Comment and Responses

This section contains each comment letter and written responses to the individual comments in each letter. This section also includes comments made to the court reporter and the transcripts of speakers at the two public hearings on the Draft IS/MND, and the responses to these comments. Specific comments have been bracketed and enumerated in the margin of the letter or transcript. Responses to each of these comments follow each letter in this Section. Each commentator has been assigned a discrete comment letter number. For the most part, the responses provide explanatory information or additional discussion of text in the Draft IS/MND. In some instances, the response supersedes or supplements the text of the Draft IS/MND for accuracy or clarification. New text that has been added to the Draft IS/MND is indicated with underlining. Text that has been deleted is indicated with ~~strike through~~. These changes have also been reflected in the Final IS/MND.

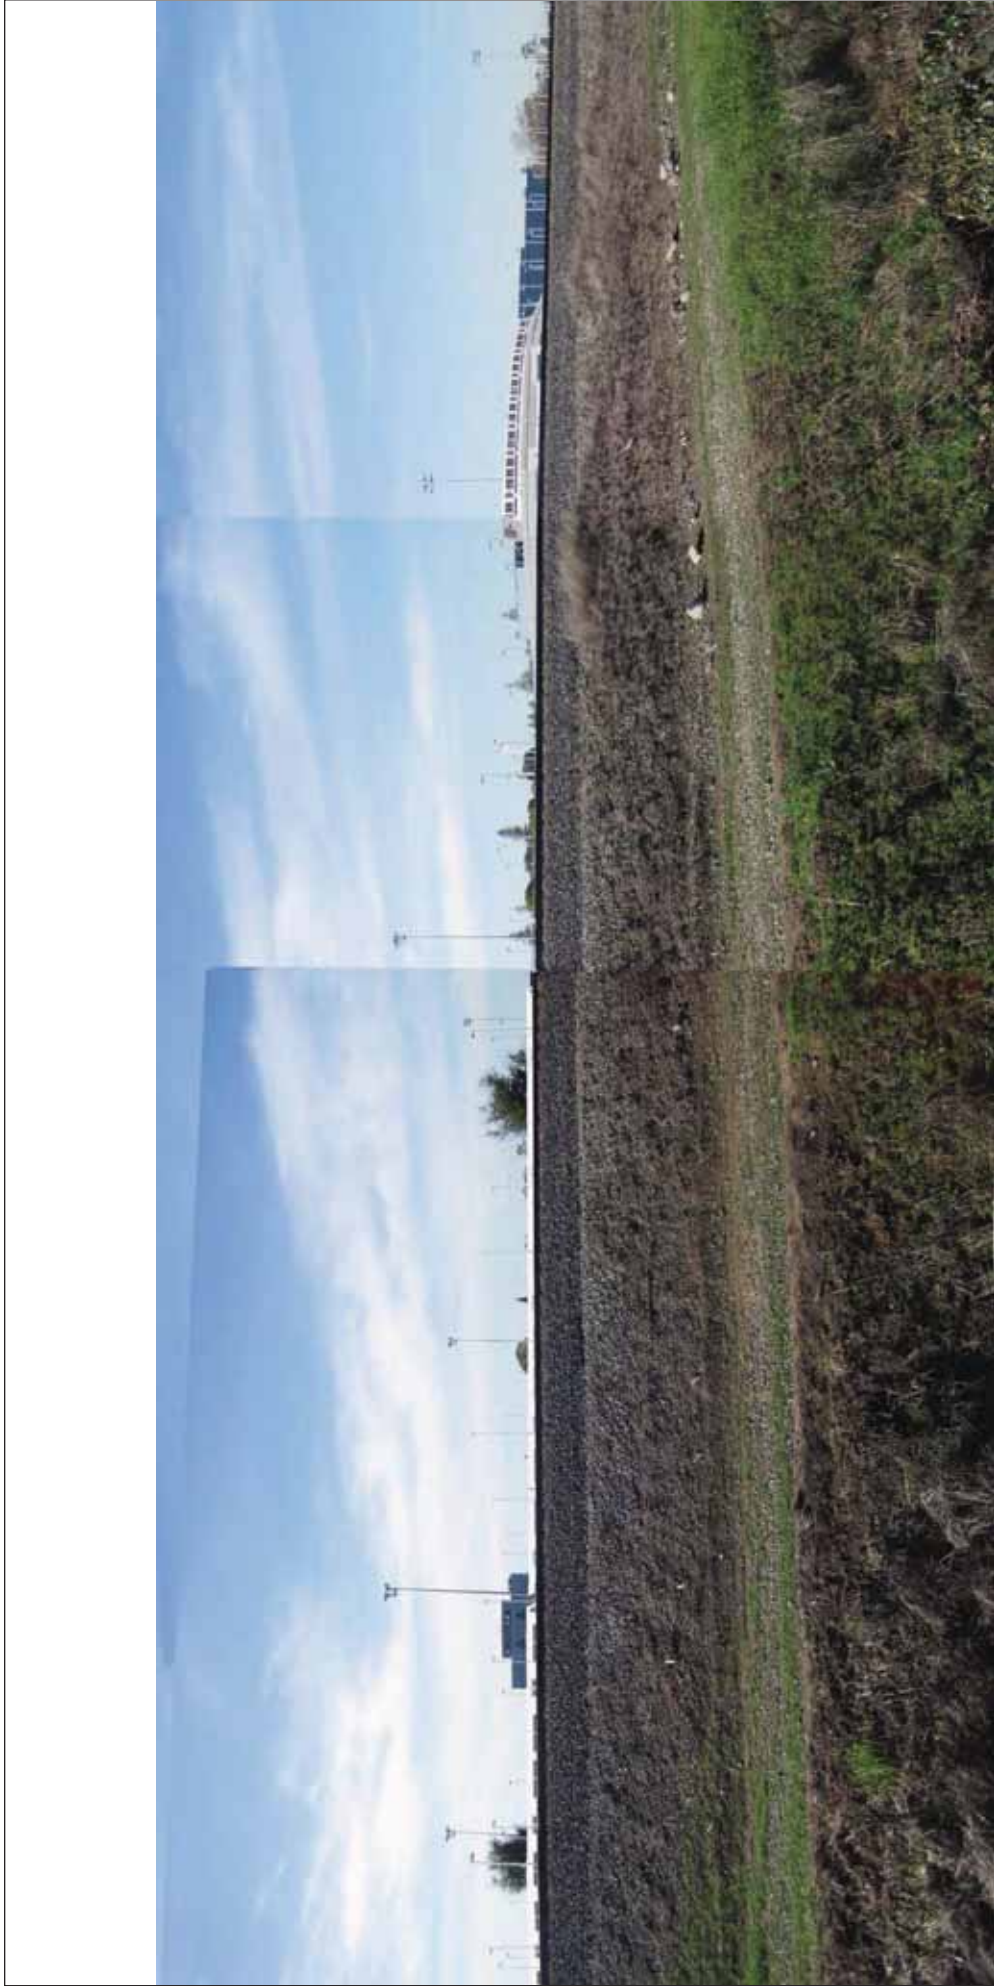
January 31, 2011 Letter from the Hayward Fire Department

Existing Condition

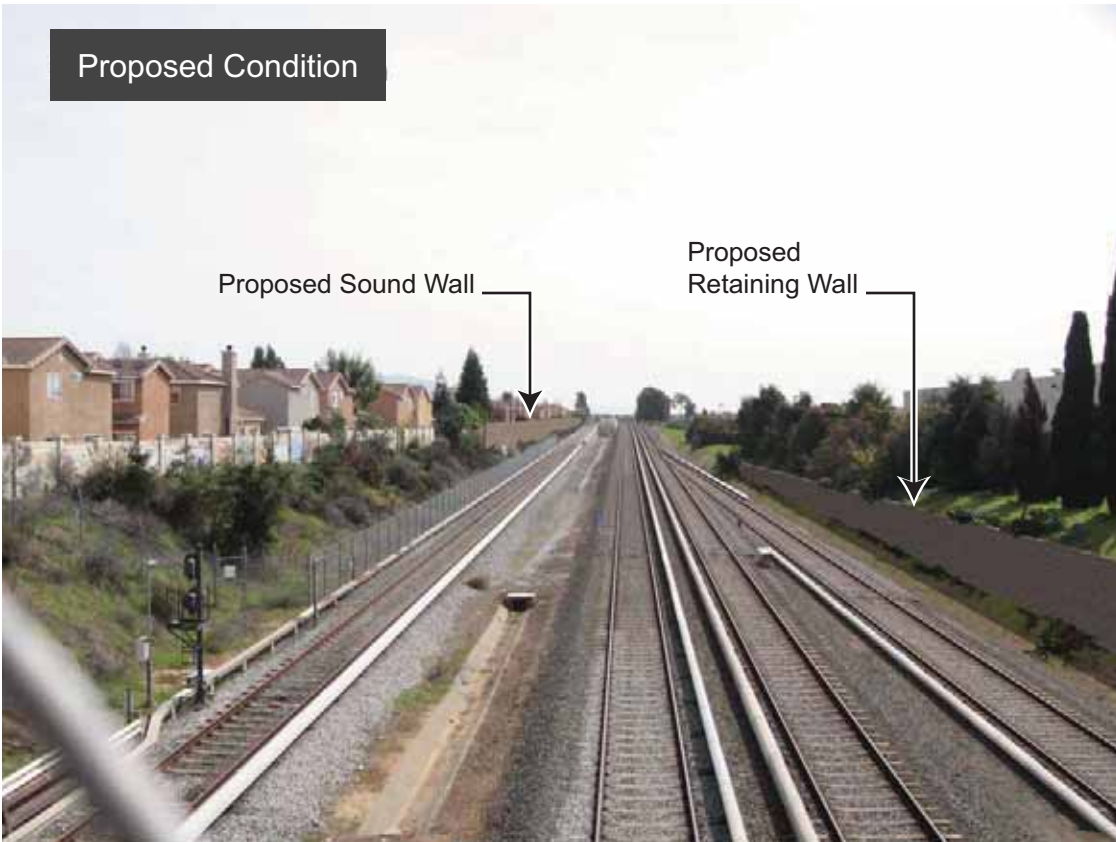
- 5-8
 - Sound wall
 - The visual impact analysis of the sound walls is inadequate. Please provide a photo simulation of the sound wall installation as seen from Calle La Mirada Common, *Dry Creek Park*, Whipple Road (looking southeast) and 11th Street. Please provide a photo simulation of Phase I completion (SW01 and SW02) and Phase II completion (SW03 and SW04).

- 5-8 In response to this comment, visual simulations of proposed sound walls (SW01 through SW04) are provided in Figures C-3 to C-6. The visual simulations show the proposed sound walls as seen from Calle La Mirada Common, Dry Creek Park, Whipple Road, and 11th Street. The proposed sound walls would be installed between the BART tracks and the existing sound walls along the properties east of the BART tracks. As described on page 28 of the Final IS/MND, sound wall (SW01), located near 11th Street and Boyle Street, would be approximately 4 feet higher than the existing 9-foot sound wall. Sound wall (SW02), located near Alicante Terrace and Carrara Terrace, would be approximately one to two feet higher than the existing 7-foot sound wall. Sound walls (SW03 and SW04), proposed under Phase 2, would be approximately one to two feet higher than the existing 7-foot sound wall. Furthermore, as demonstrated by the visual simulations in Figures C-3 to C-6, construction of the proposed sound walls would not result in visual obstruction of any significant views, and would be consistent with the existing visual character of the areas in which they would be installed. Therefore, the visual effect of the sound walls would be less than significant, as described in the Final IS/MND.
